Property of : Electronics Design		Rev : 1	Sub : 0
Project : SCSI Device			
Subname : Atari 8 bit		Date : 31-mrt-2004	
Hardware Engineer :			
Company : Electronics Design			
Address :			
City :			
State :			
Initial date March 2004	Page : 2	of : 2	1

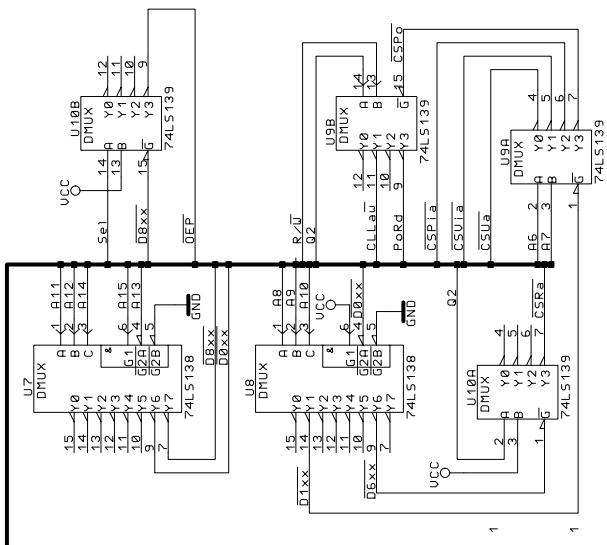
Changes needed for extra Ram option:

- 1) Replace Ram chip with 62256
 - 2) Make sure that pins 1 and 26 are connected. see sheet 1
- For 64K Ram
- 1) Replace Ram Chip U5 with two 32K Ram chips in "Piggy-Back" mode
 - 2) Make sure that pins 1 and 26 are connected
 - 3) Connect Pin 3 of U10 to Pin 11 of the 6821
 - 4) Connect Pin 5 of U10 to pin 20 of the top Ram
